# Access Compliance Report

## Public Rights-of-Way

### (Pedestrian Signals)

Intersection ID: N/A	Main Street:	Cross Street: N/A	Location: N/A
ADA ID: 20E1E8DDBA90	Signal Type: One Push Button-Non APS	Overall Compliance: No	Severity Score: BTN 1: N/A BTN 2: N/A No BTN: N/A
Codes/Mitigation Info/Possible Solution		Field Measurements/Component Compliance

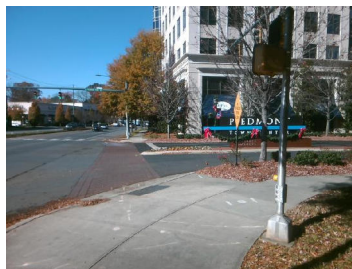
PROW/ADA: TMUTCD 4e.08, R406.2

Possible Solutions: Replace Signal Push Button With APS Button on New Post. Remove & Relocate Sign.
